2nd Public Workshop on the RIA Interim Acceptance Criteria

**Paul M. Clifford
Sr. Reactor Engineer
U. S. Nuclear Regulatory Commission
December 19, 2006**

Non-PCMI Failure Criteria

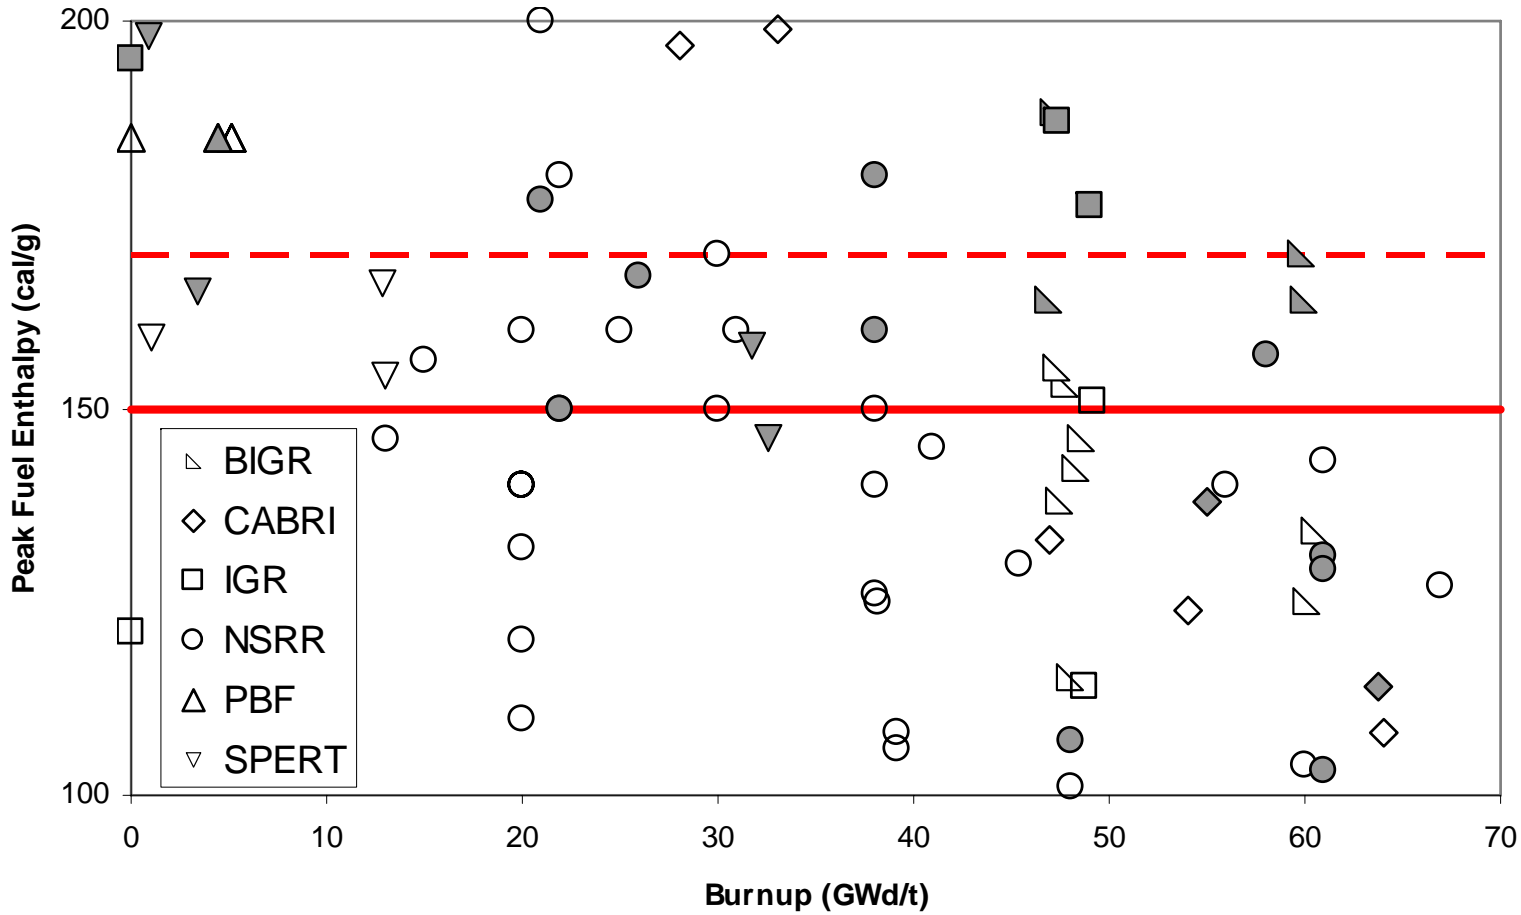
- Maintain 170 cal/g
- Not applicable to at-power conditions
- Define zero enthalpy temperature

PWR PCMI Failure Criteria

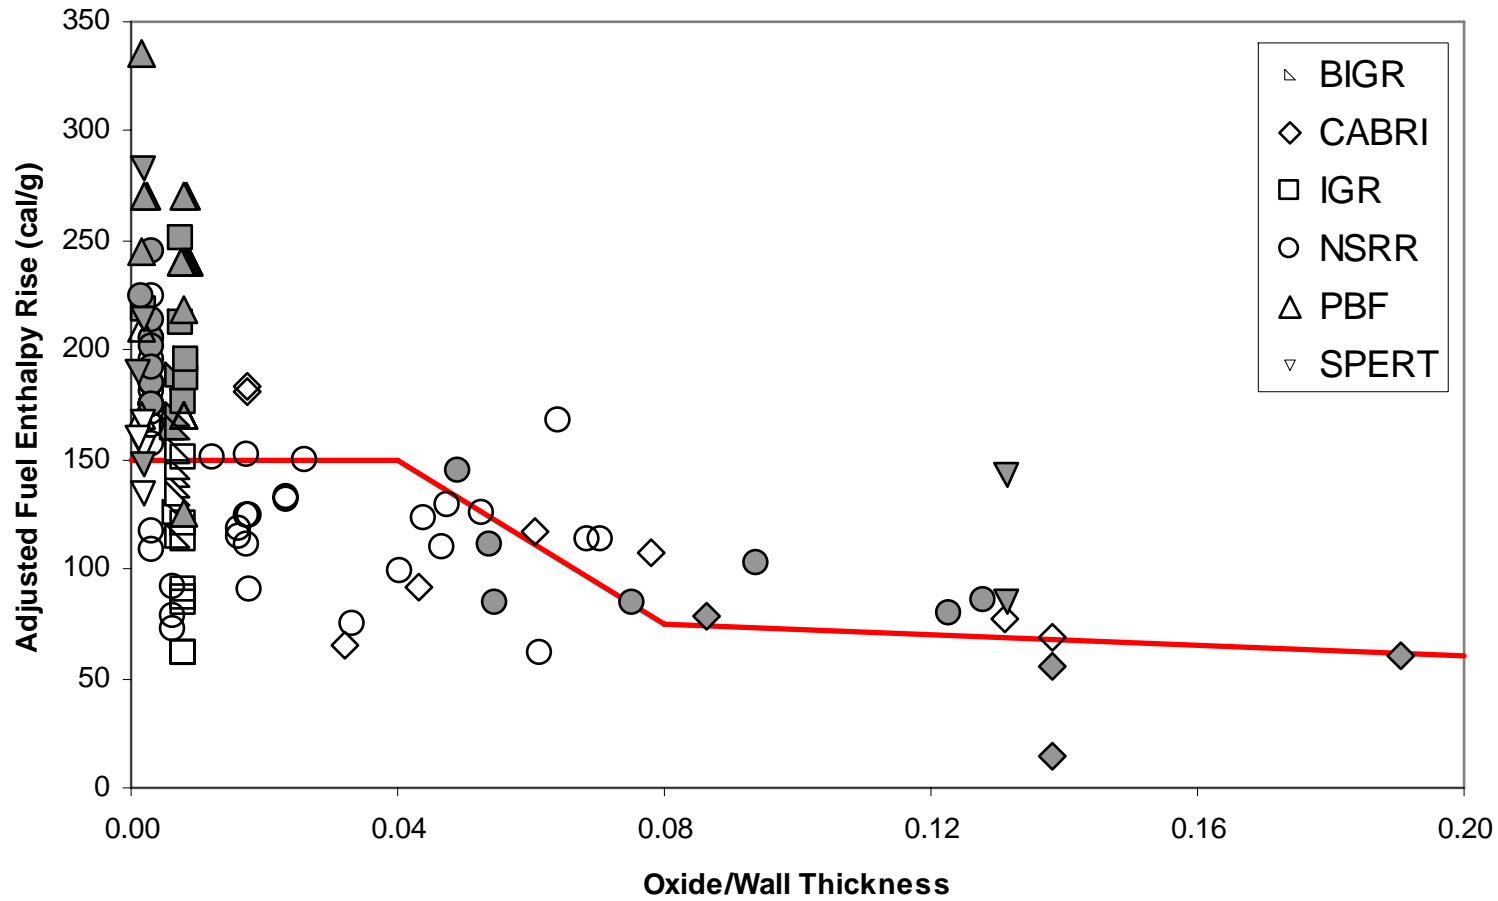
- Allow alternative criteria
- Remove REP Na-7 MOX test
- Remove low corrosion NSRR tests
- Re-word text to state hydrogen is key factor
- Use nominal cladding thickness
- Prompt fuel enthalpy rise vs. delayed rise

BWR PCMI Failure Criteria

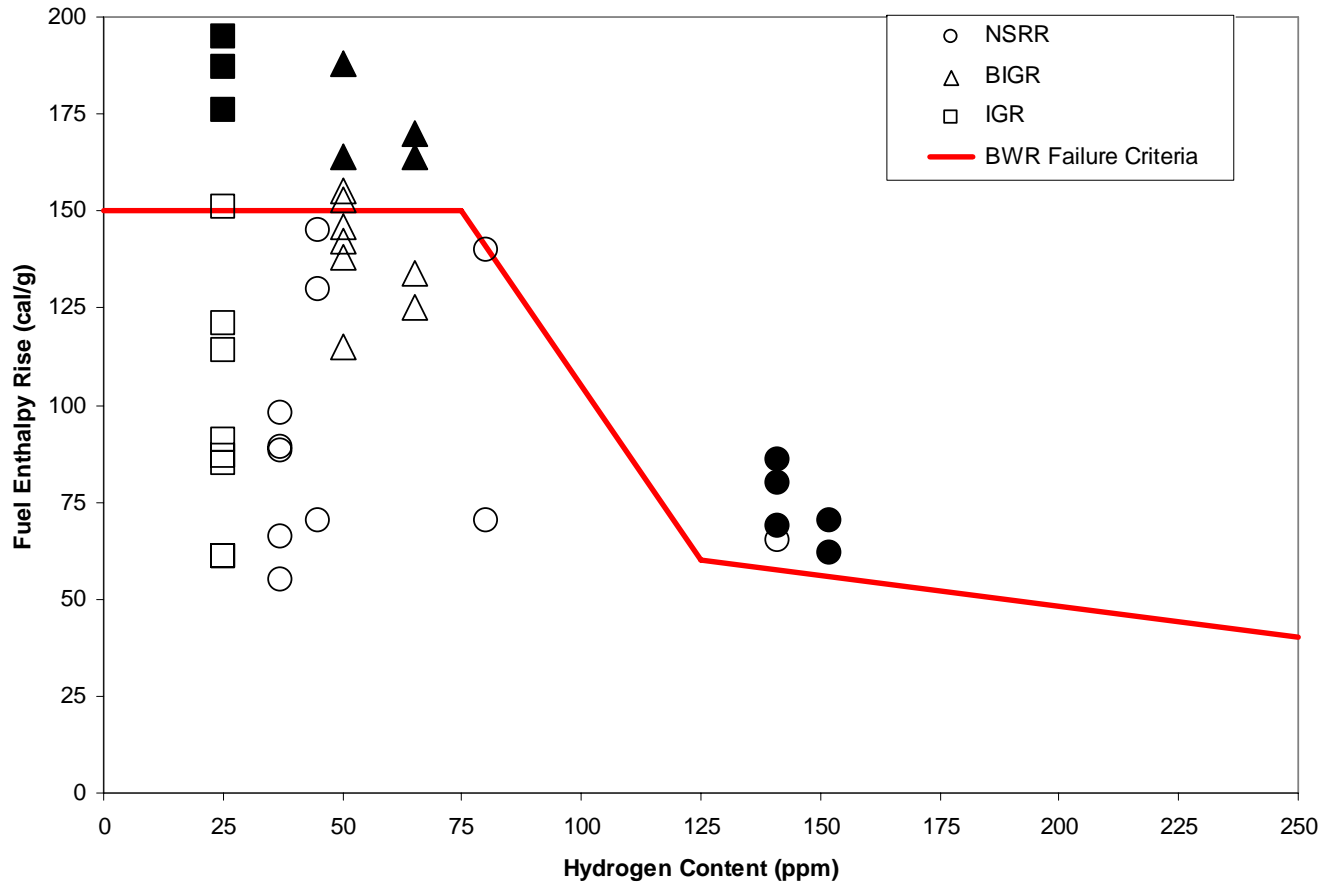
- Allow alternative criteria
- Excess hydrogen vs. hydrogen
- Scale NSRR tests for pulse width
- Prompt fuel enthalpy rise vs. delayed rise

- Measured vs. predicted hydrogen content
- Availability of NSRR and Cabri hydrogen
